10 November 2021

RE: PART TWO AMENDMENT FOR THE APPROVED BRANDVALLEY WEF NEAR MATJIESFONTEIN IN THE WESTERN AND NORTHERN CAPE

14 April 2022

RE: AMENDED LAYOUT FOR THE APPROVED BRANDVALLEY WEF NEAR MATJIESFONTEIN IN THE WESTERN AND NORTHERN CAPE

Map 1: Amended final layout of the Brandvalley WEF

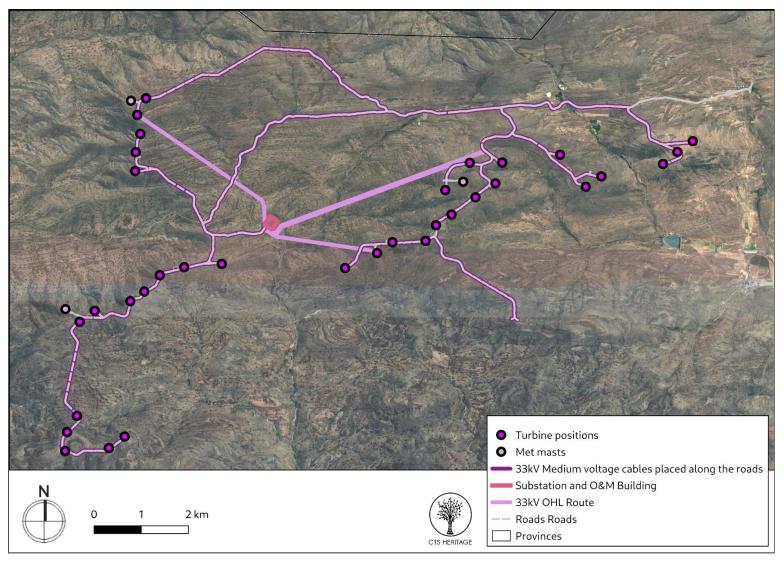
The following amendments are proposed to the Authorised Brandvalley WEF as part of this Part 2 Amendment Process:

- Turbine positions: 34 turbines per project so reduced substantially from the +/- 60 positions permitted in the EIA.
- Hardstands The exact orientation, position and dimensions of the hardstands will be subject to minor change pending the final selection of the TSA. The footprint shown is less than the 3500 m2 per hardstand as per the EIA. The client has indicated that this should be achievable but is very tight it would be preferable if an increase to 4500 m2 per hardstand can be substantiated due to the reduction in total number of positions (3500 m2 x 60 / 34 = 6000 m2 so total footprint would still be substantially less than assessed in EIA)

- Roads the 9m and 12m widths stipulated in the respective EIAs this is assumed to be the riding surface of the roads additional width for cut / fill earthworks are not included

- Substation & O&M facility No variation from size and position in EIA
- MV Collectors buried cables All buried cables follow the road routes
- Site Camp & Laydown area & Batch Plant Preferred site camp, laydown area and batch plant areas shown as indicated by the contractors. The total / cumulative area is within the limits prescribed in the EIA. The contractors have indicated that for logistic reasons they would prefer to have the batch plants more centrally located and slightly away from the site camp and laydown area. This is preferable but not essential – if, for environmental reasons, we need to relocate the batch plants adjacent to the site camp / laydown area then we can live with this.

As with the previous layout, some of the heritage resources known from this area are located along the proposed road alignments. The road alignments have been slightly amended in the proposed amended layout, however it is not anticipated that these amended road alignments will negatively impact on significant archaeological heritage. Furthermore, it is not anticipated that the proposed change in turbine height and reduction in turbine numbers will negatively impact on heritage resources.

This letter is therefore drafted to confirm that the final amended layout dated November 2021 for the Brandvalley WEF does not impact any known heritage resources and adheres to the recommendations included in the CTS Heritage Walkdown report for this development (September 2021) which concludes that "The final layout for the Brandvalley WEF avoids impact to all known significant heritage resources present within the development area. The walkdown of the final layout revealed no new significant heritage resources that are likely to be impacted. It is therefore recommended that this report is accepted as satisfying this condition of the Environmental Authorisation issued for the Brandvalley WEF project."

Map 2: Amended final layout of the Brandvalley WEF overlain with the Approved Brandvalley WEF Layout

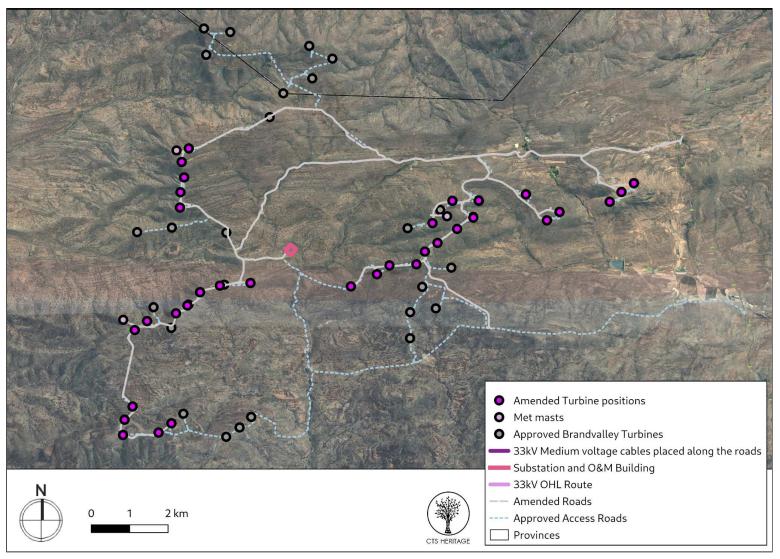
However, please note that the proposed alignments for the 33kV Overhead Lines (OHL) were not assessed as part of the Walkdown process (Figure 2). As such, there remains a risk that the construction of these overhead lines may negatively impact on significant archaeological or palaeontological heritage and as such, it is recommended that the proposed locations of the footings for the pylons for the OHL be inspected for such impacts during the construction phase of the development.

Map 1: Amended final layout of the Brandvalley WEF

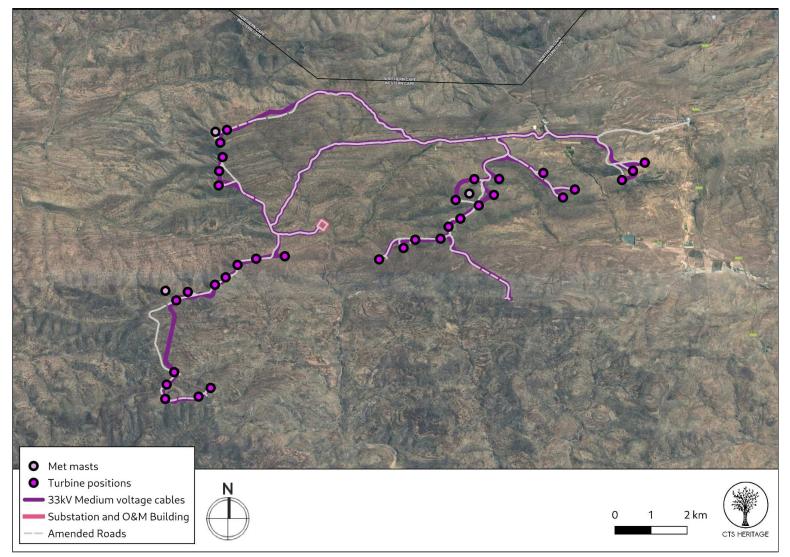
The proposed amendments consist of minor deviations (maximum deviation of approx. 600m). As with the previous layout, some of the heritage resources known from this area are located along the proposed road alignments. The road alignments have been slightly amended in the proposed amended layout, however it is not anticipated that these amended road alignments will negatively impact on significant archaeological heritage.

This letter is therefore drafted to confirm that the amended layout dated April 2022 for the Brandvalley WEF does not impact any known heritage resources and adheres to the recommendations included in the CTS Heritage Walkdown report for this development (September 2021) which concludes that "The final layout for the Brandvalley WEF avoids impact to all known significant heritage resources present within the development area. The walkdown of the final layout revealed no new significant heritage resources that are likely to be impacted. It is therefore recommended that this report is accepted as satisfying this condition of the Environmental Authorisation issued for the Brandvalley WEF project."
